**Flood Risk Assessment and
Drainage Strategy Technical Note -
Updated Drainage Strategy**

Project: Ford Airfield – The Landings
Arundel

Reference: C85228-JNP-XX-XX-RP-C-1000 P02

Subject: FRA and Drainage Strategy Technical Note – Updated Drainage Strategy

Fig 1 1910 Historic map of the site showing the ditch

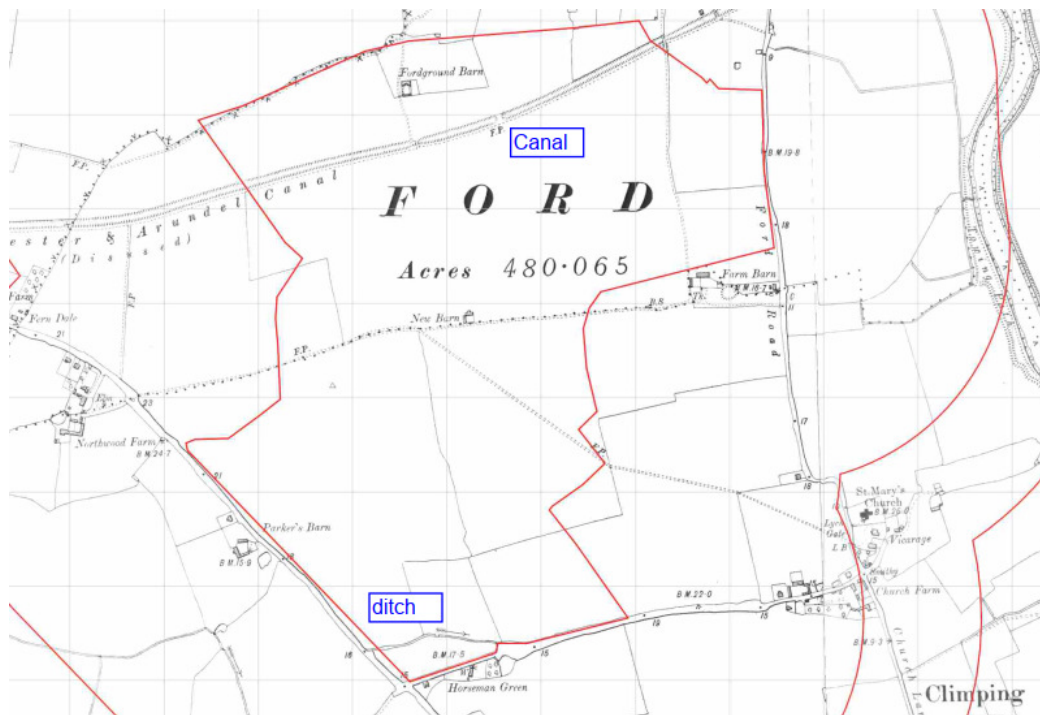
- 4.1 The ADC Drainage Engineer has advised that *"at least one culverted watercourse is believed to cross the site (southern area), but there may be more, since some of the infrastructure (across the airfield) may have been laid in former ditches"*.
- 4.2 Copies of historical maps for the Ford Airfield Site are provided in Appendix B. Maps are provided for 1876, 1896, 1910, 1950, 1961, 1966, 1978, 1981, 1992, 2002, 2010 and 2014.
- 4.3 Only the 1910 map shows a ditch to the south of the site flowing eastwards. An extract of the map is provided below:

- 4.6 This historic ditch is located within proposed greenspace. If a culvert is uncovered at this location, and proven to be a live connection, it can be diverted within the greenspace and connected to the existing 450mm dia outfall sewer.

Fig 2 Extract from CD Surveys drainage investigation drawing showing extent of trace at the suspected culvert. Jan 2019

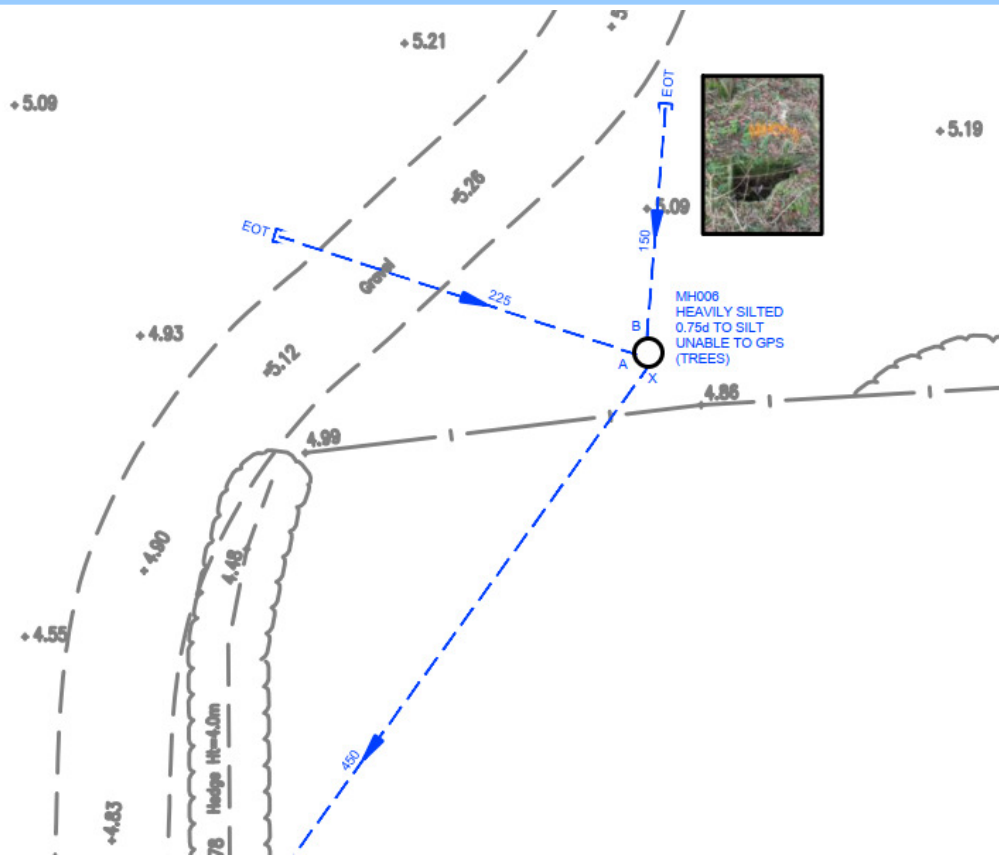
- 4.4 The outfall from the historic ditch appears to coincide with the 450mm dia sewer pipe which leaves the site boundary in Horsemere Green Lane.
- 4.5 In January 2019 CD Surveys attempted to trace this sewer onsite but were forced to abandon the survey of the incoming sewers due to heavy siltation.

Fig 8 Difference in existing ground levels across the south of Ford Airfield

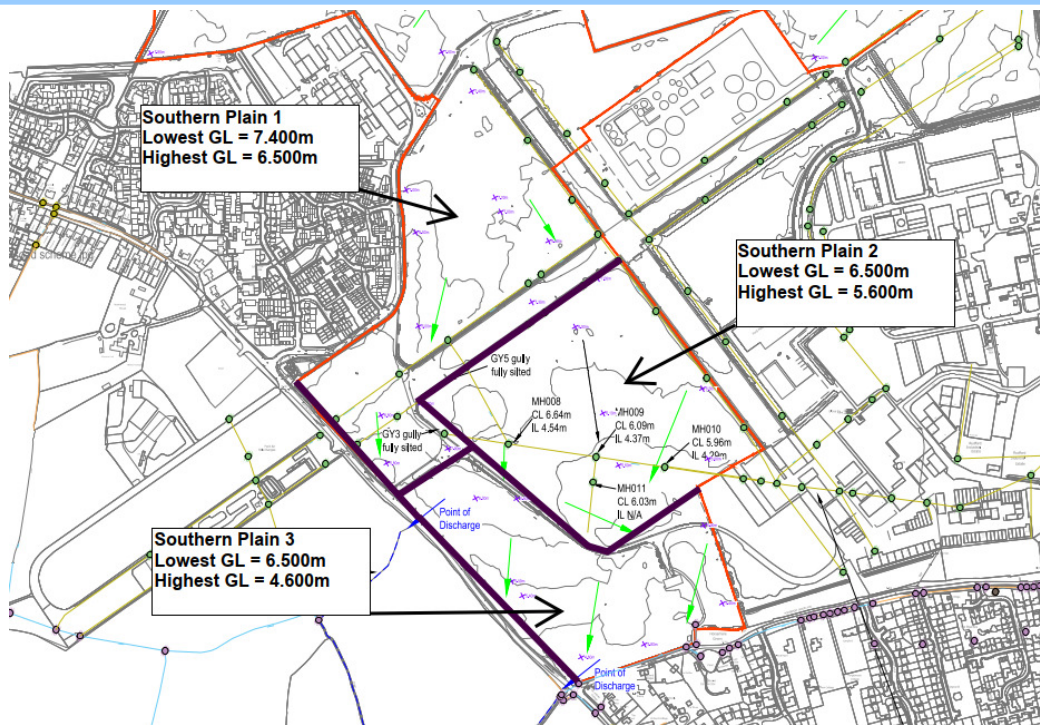
- 14.1 The ADC Drainage Department raised the following comment regarding finished ground levels:
“it is noted that ground levels will be raised across the site. The applicant needs to ensure that there is no negative drainage impact on adjacent developments/ infrastructure as a result.

- 14.5 The south of the site is flatter than the north. JNP Drawing No C85228-SK130, titled Existing Catchment Areas and Points of Discharge, provided in Appendix B, shows the difference in existing ground level across the site. The diagram below shows indicative highest and lowest ground levels across the south of the site.

- 14.6 Sections 10.5 to 10.17 above demonstrate that infiltration across the south of the site is not feasible and providing an attenuation basin which discharges via a pumping station requires significantly less raising of existing ground levels across the site, when compared to other options. Therefore, it carries the least environmental impact in terms of importing fill to site for earthworks.
- 14.7 The difference in ground levels between the existing ground and proposed finished levels for the pumping station solution are provided in JNP Drawings C85228 D111 titled Indicative Proposed Ground Levels, provided in Appendix I. This is covered in more detail in the FRA and Drainage Strategy Report reference is C85228/ R001E dated 14 February submitted for outline planning.
